FCC ID: IQX98C1770

Re: About the modification of 17" COLOR MONITOR

FCC ID: IQX98C1770
Front side of general appearance

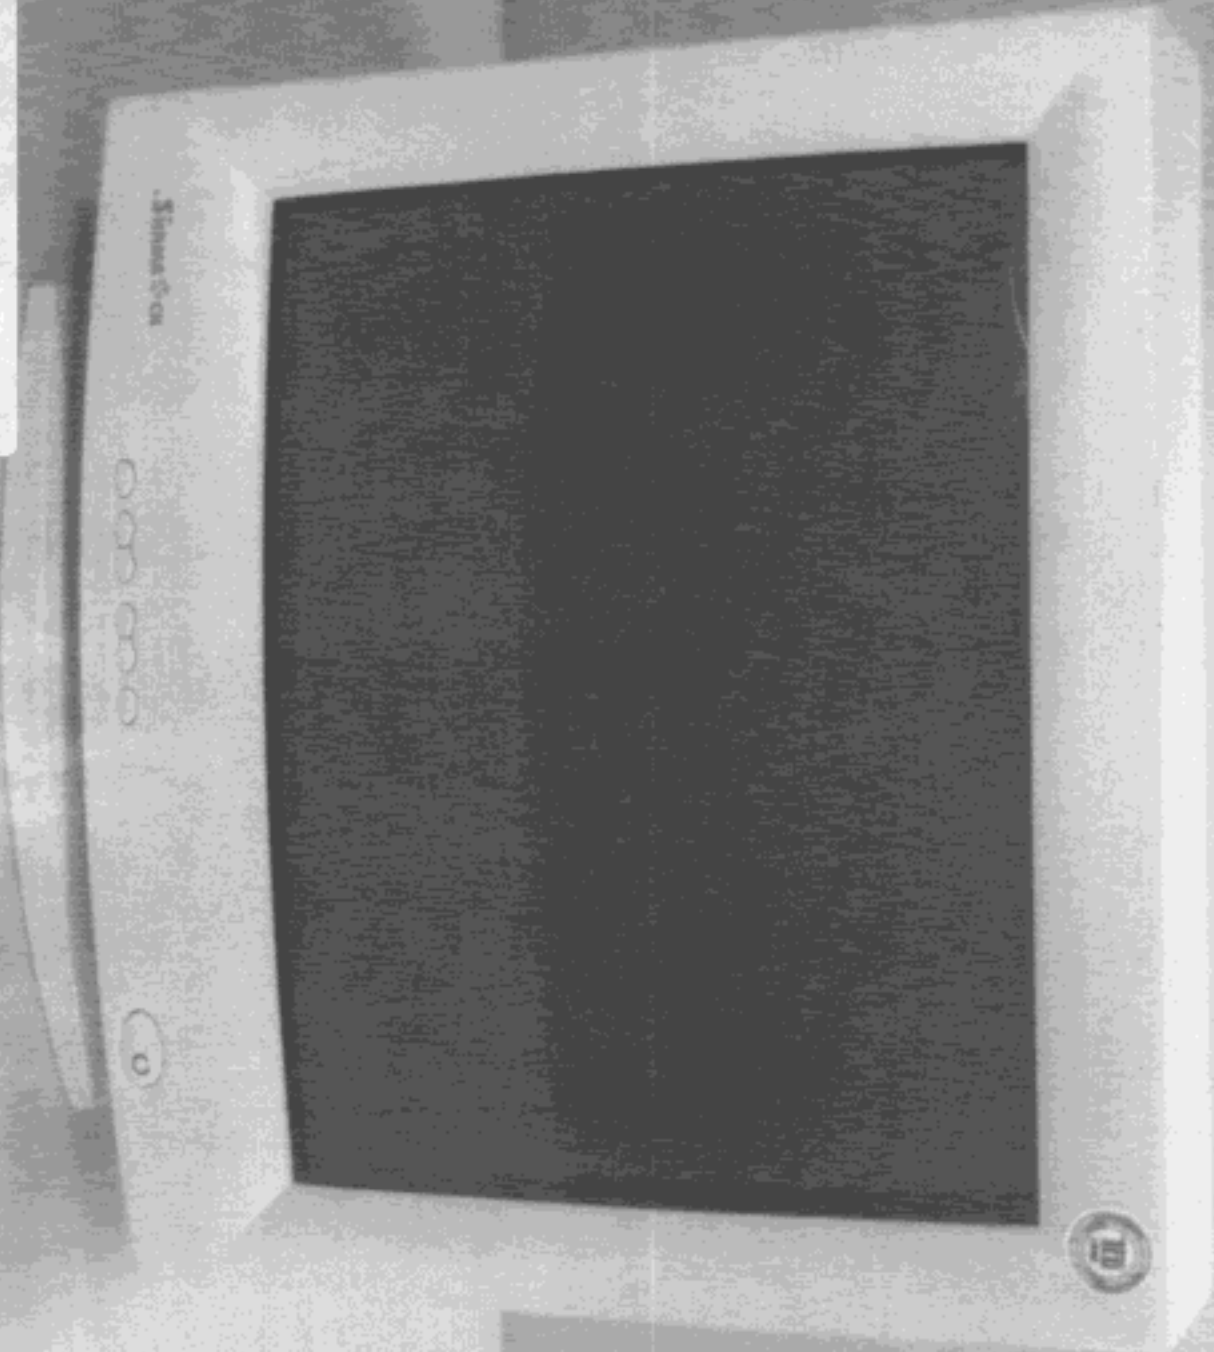
1. Add ferrite core on video cable .
(As the photo No. 2)
2. Add metal shield on CRT board .
(As the photo No. 5)
3. Add ferrite core on video cable. *braid*
(As the photo No. 5)
4. Add ground wire x 3ea from CRT board wire to main board & CRT board metal shield.
(As the photo No. 6)
5. Add ground wire x 2ea from *CRT* Braid wire to main board.
(As the photo No. 7)
6. Add jumper wire on CRT board from Q307 Heatsink to CRT socket GND.
(As the photo No. 11)
7. Add jumper wire on main board from U202 PIN 1 to C726.
(As the photo No. 13)
8. Add jumper wire on main board from C132 to C12P.
(As the photo No. 13)
